Supplemental Information - Appeal of project 598124 - Federal Blvd. Marijuana Outlet

Tuesday, December 4, 2018

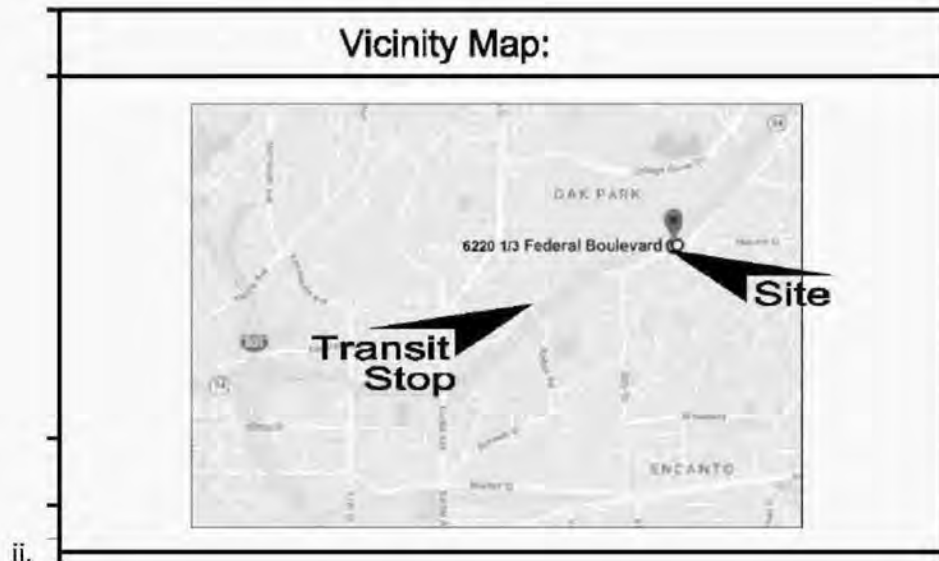
ii. Existing Use is Missing in project information on sheet CS

- iii. Year of original construction for permanent structures is Missing in project information on sheet CS, although a series of images were provided by the applicant which clearly depicted permanent structures, as defined by the California Building Code, located on the site. (snapshots of actual drawings below).

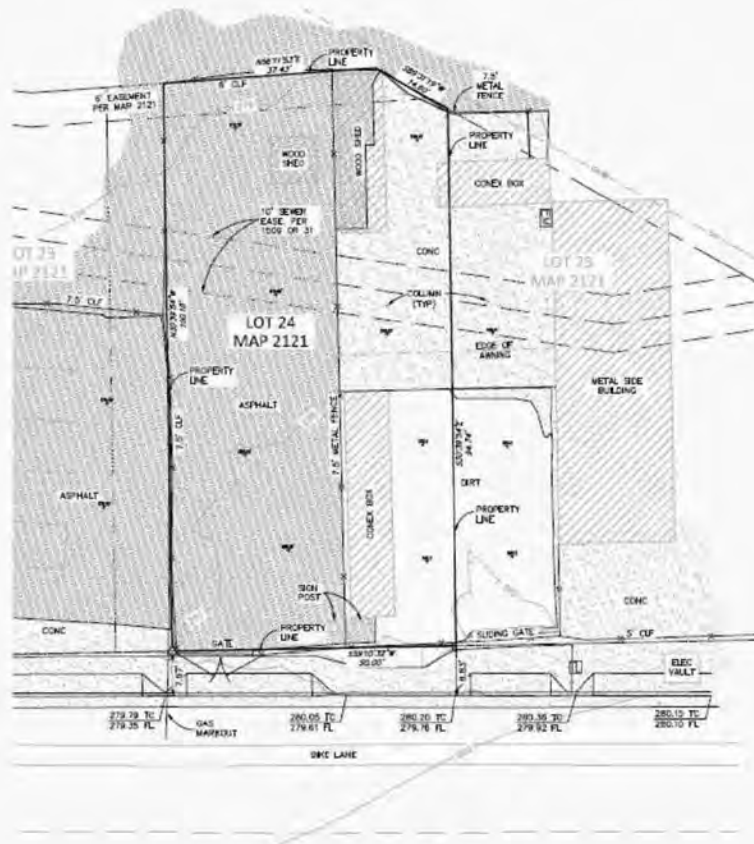
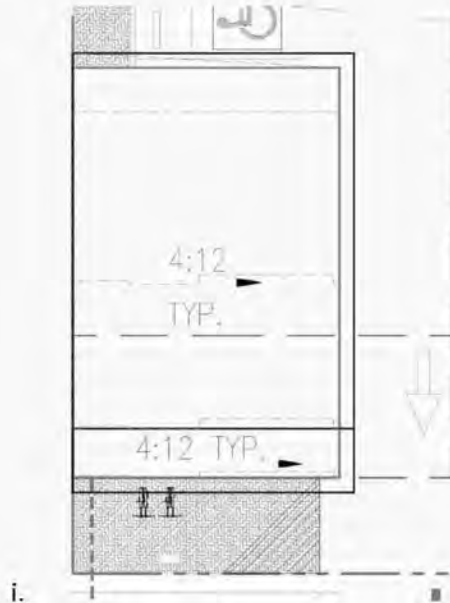
- i. Site plan on Sheet SP2 is Missing the required drainage pattern depiction.

- i. Site plan on sheet SP2 is Missing Site Section Lines depicting cross sections through the entire site in at least two directions.

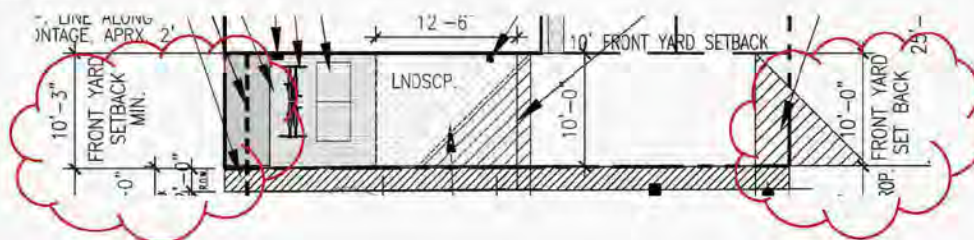
Although the areas called out increased dramatically, there was no change to the plan drawings depicting an increase. Are the plans correct, or are the numbers correct? One can't determine that by simply reading the drawings.

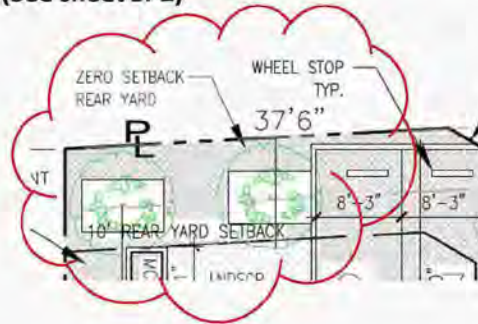
- 3.6. 11/20/2018 plans conflict by calling out a “Zero Setback Rear Yard” while also showing a 10’ Rear Yard Setback. (See sheet SP2)

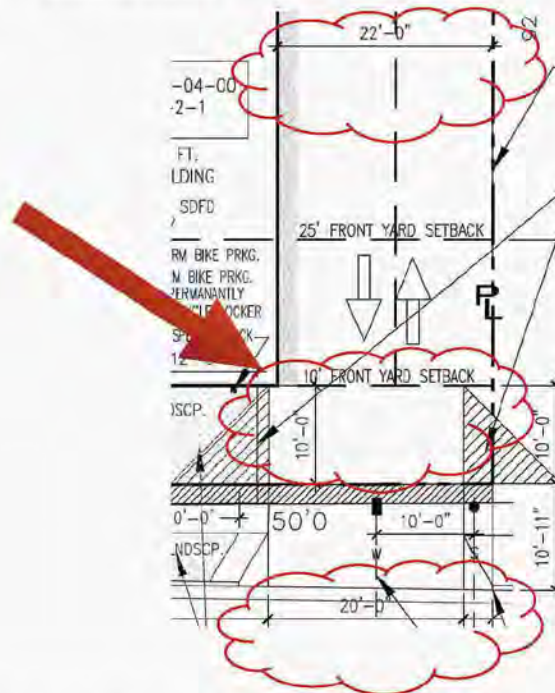
- 4.1. A 20’ driveway curb opening width (with aprons 3’ on both sides driveway) is proposed. As the driveway width interfaces with the drive aisle width of 22’, the building becomes an obstacle that requires the driveway width to be reduced as it connects to the 22’ drive aisle. (See sheet SP2). The project fails to provide the minimum 20’ driveway since the building is an obstacle.

The proposed driveway design is not compliant. A corner of the building would have to be removed in order to provide for an appropriate transition.

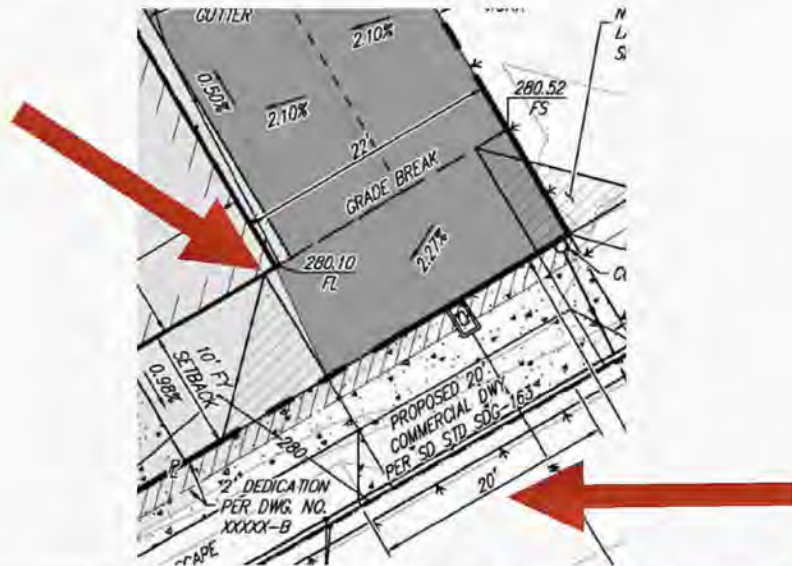
- 4.2. **Sheet C.2** conflicts with sheet SP2. The dimension depicting the width of the driveway indicates a driveway located approximately 4' in front of the building. This drawing is both non-compliant and also not consistent with the other submitted site plans.

- 4.3. The driveway width is reduced and not correctly shown on the Site Plan (**SP2**), Roof Plan (**A2.00**) and Floor Plans (**A1.00**) angling inward and Landscape (**L1, L2**). The proposed driveway design, which is inconsistent with the other submitted drawings, also does not comply as it depicts a driveway that is both not parallel to the front property line and also does not maintain the minimum required width of 20'.
